Revision Description	Date	Rev. No.	Issued by
LRD Amendment Application	09-10-2026	A3-C01	MM

Project: Player Wills
Location: Former Player Wills Site, South Circular Road, Dublin 8
Client: CWTC Multi Family ICAV

Drawing Title: PW2 - Proposed Level 02 Plan
Drawing No.: 25068-OMP-PW2-02-DR-A-1002

PW2 - Proposed Level 02 Plan

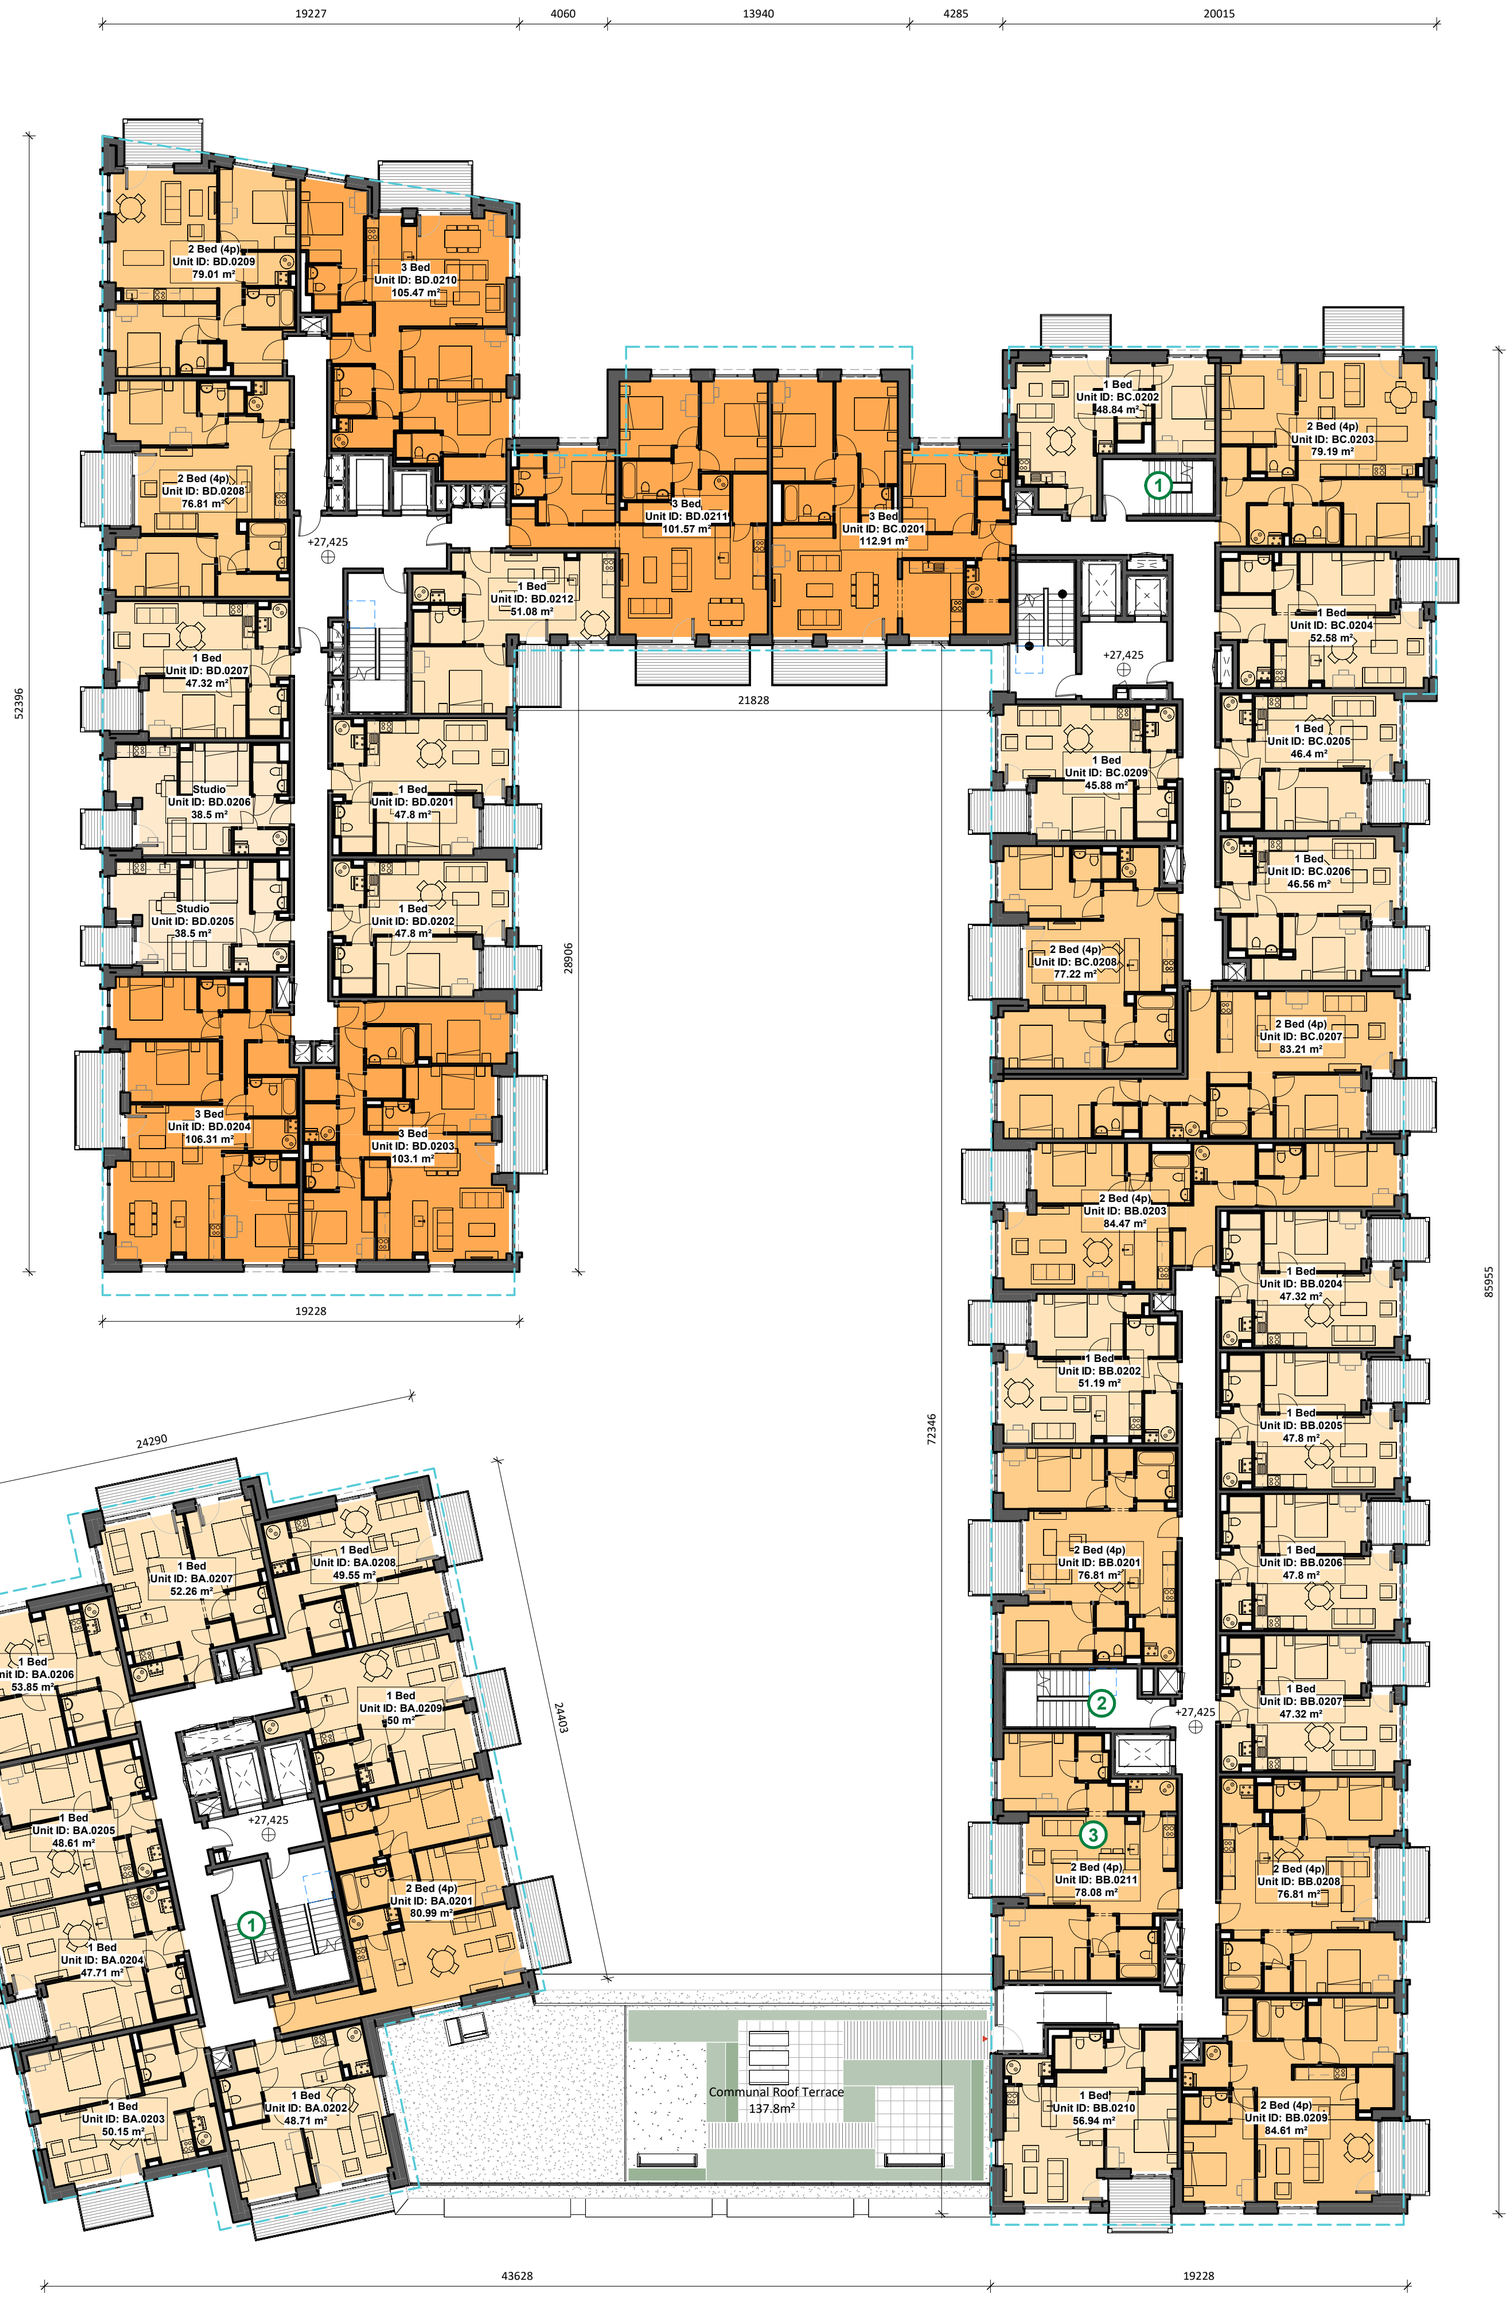
1. Provision of a second stair in accordance with updated Building Regulations (TGD Part B), with associated reconfiguration of layouts.
2. Reconfiguration of core layout resulting from design development and vertical transport assessment
3. Conversion of permitted 1-bed to 2-bed unit
